# *The City of Spartanburg Design Review Board*

## **AGENDA**

**December 3<sup>rd</sup>, 2024, at 5:30 P.M.**

DRB-24-020-00014

SITE + BUILDING FOOTPRINT @ 1/32" = 1'-0"

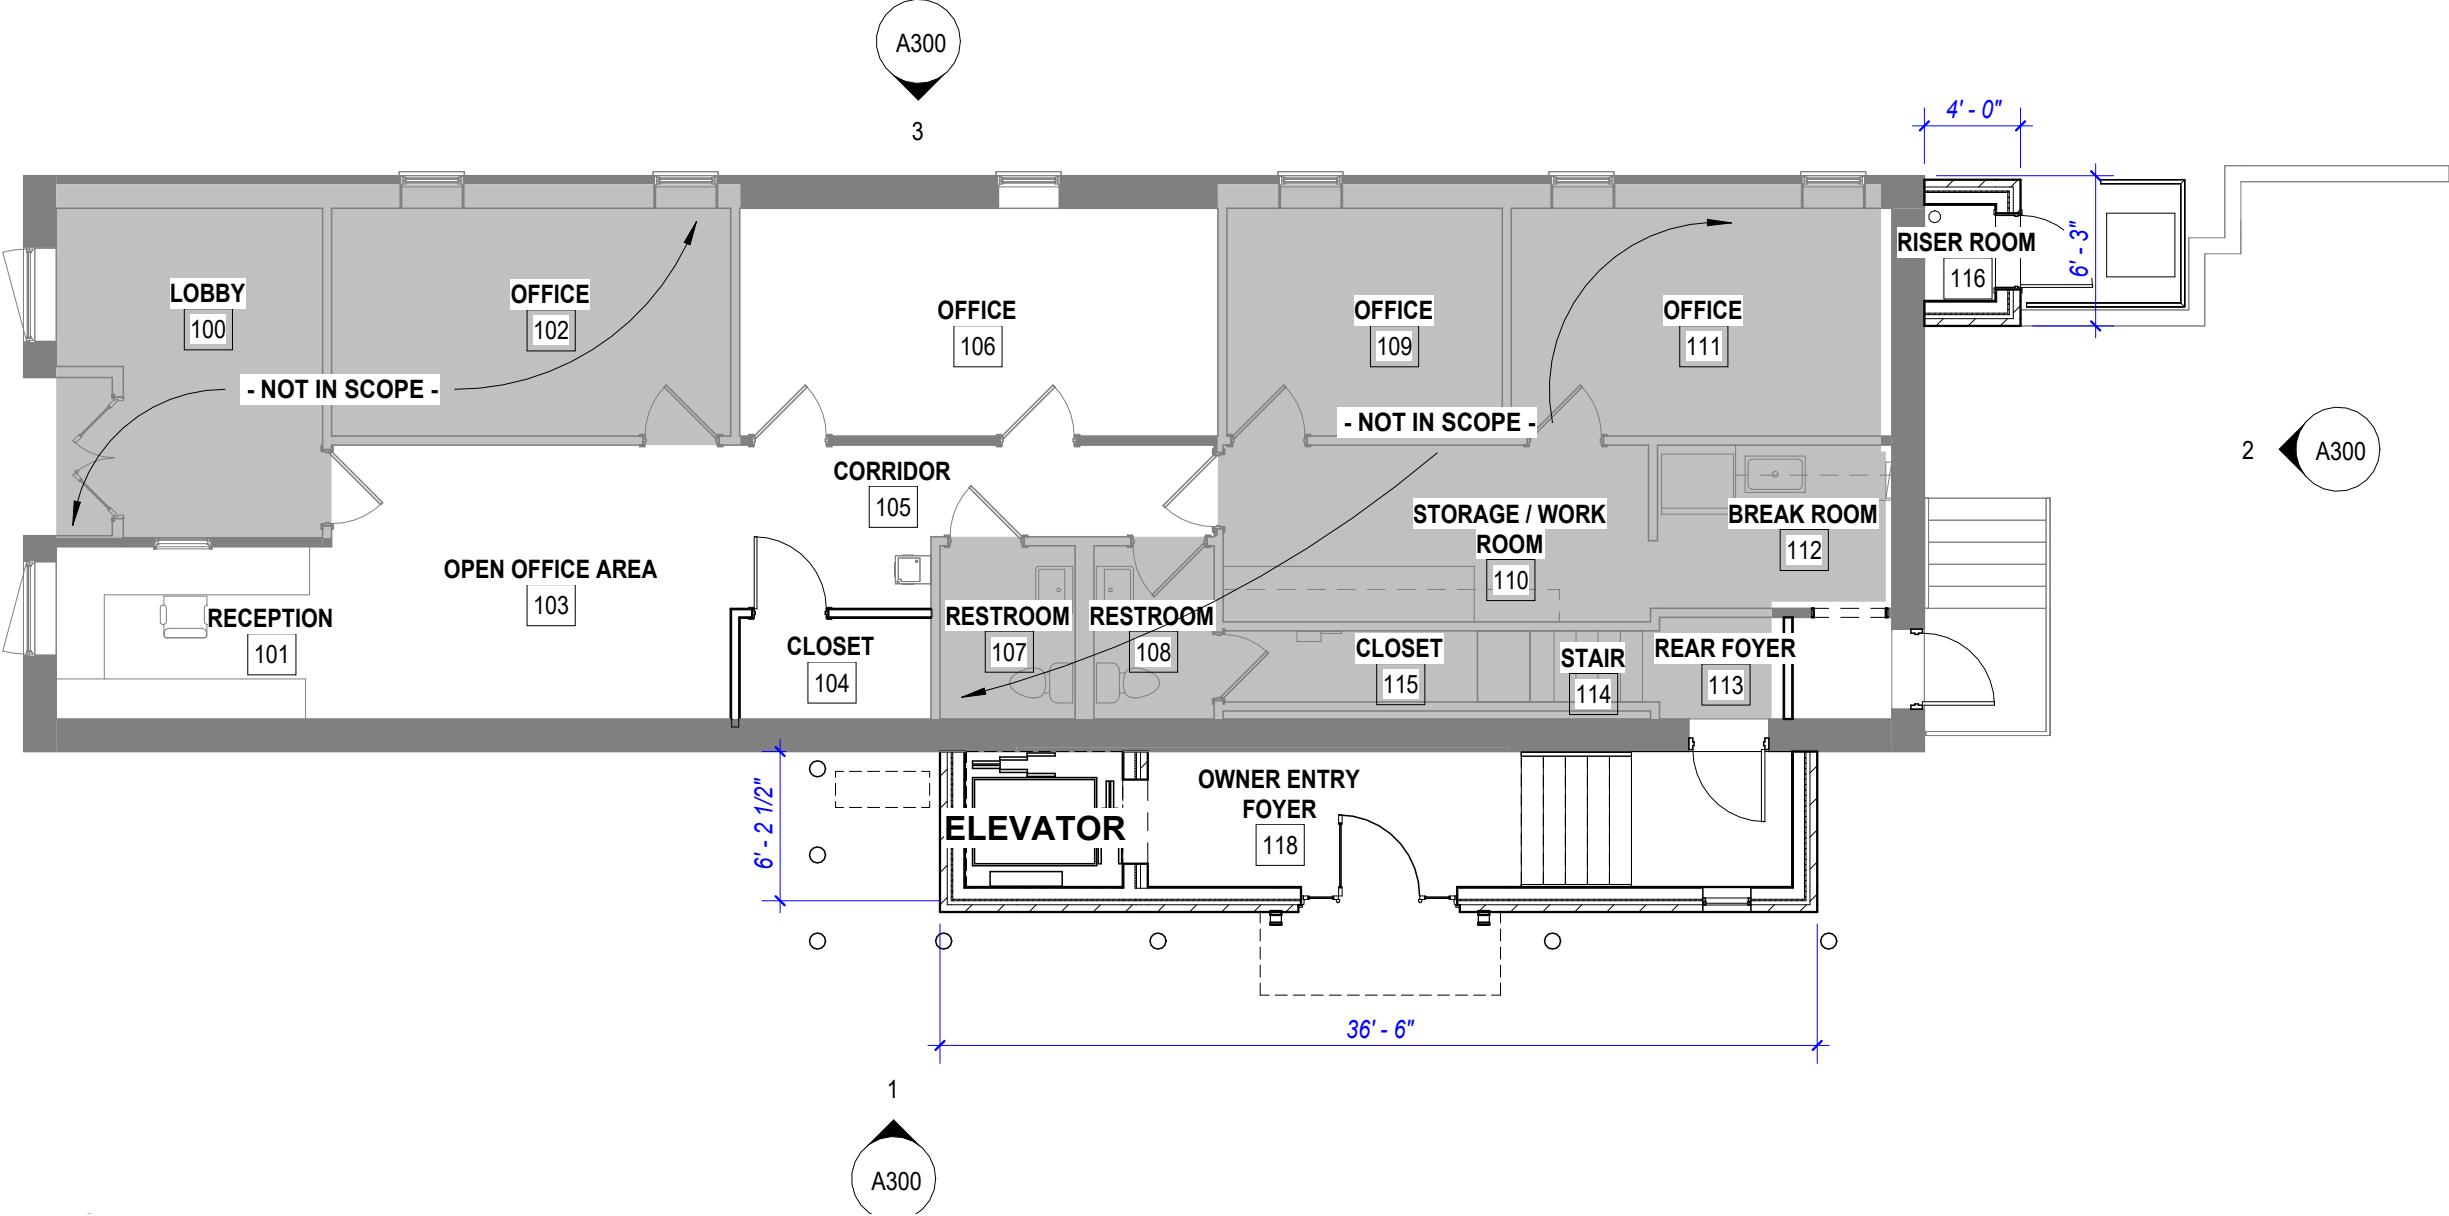
- 7.2 Bicycle Parking: A minimum of 2 bicycle parking spaces shall be provided. *Bicycle parking is not shown on the submitted plans. Please provide.*

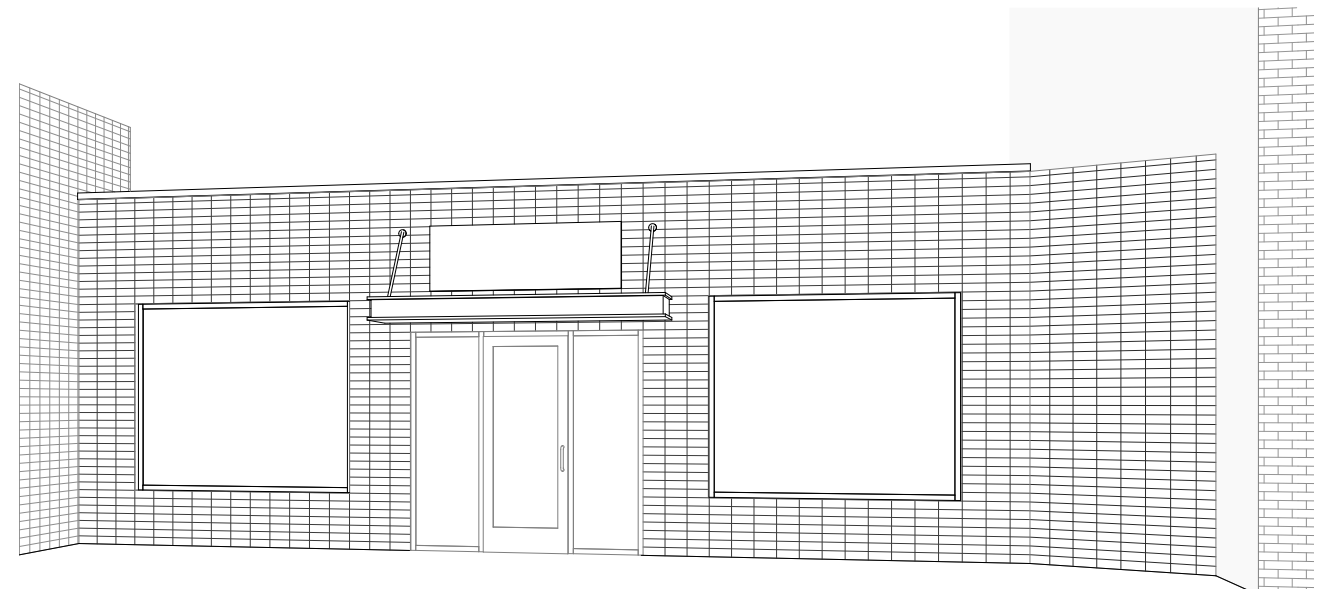
- **Brick Painting:** Painting of structures and color selection are not formal DRB review items. However, recommendations are occasionally presented. The Preliminary Review encouraged the applicant to consider cleaning and repointing the existing brick in lieu of painting.  
*The existing buff-colored brick and its unique, non-offset coursing is a common detail for mid-century modern buildings. The style itself is one that is intended to reflect the authenticity of the materials and to evoke a more horizontal feel to the façade. In addition, because brick is itself a porous material, painting it, according to the Brick Association, creates a barrier that can trap moisture inside. For most structures, painted brick requires more frequent maintenance and for some structures, painting it can cause mold and mildew growth on the interior and exterior.*

- The applicant indicated their preference to paint the building and agreed to provide the color sample of the paint noted in the renderings along with a sample of the window casing during the Full and Final review.

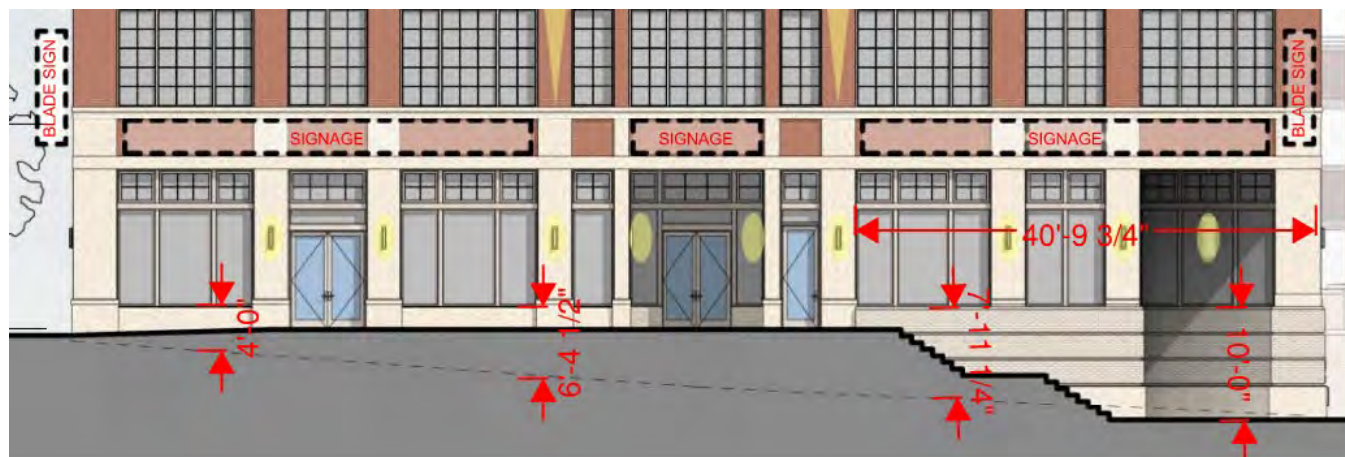
**Building Height:** The Design Review Board shall use the incentives noted in Section 3.5 as guidelines in their review but shall also have the discretion to ensure that the overall scale, massing, and frontage of the structure is compatible with other structures within adjacent blocks. Height exceptions are permitted subject to compliance with one of the height bonus options LEED Certification, Mixed-Use, or through a rezoning to DT-6. In this instance, a restaurant is proposed for the office building.

**Arcade Treatment:** The proposed “arcade” creates a unique right-of-way condition for Batter’s Alley. The arcade will require a permanent pedestrian easement (or similar document) for the applicant to provide City and the general public unrestricted access.

- Further exploration of design concepts that enhance the pedestrian amenities, specifically along W. Main Street, and eliminate the sidewalk pinch created by the tree wells and parking spaces is recommended. The City’s goal is to enhance the pedestrian environment and movement, recognizing the redevelopment in the immediate area will provide sufficient parking.
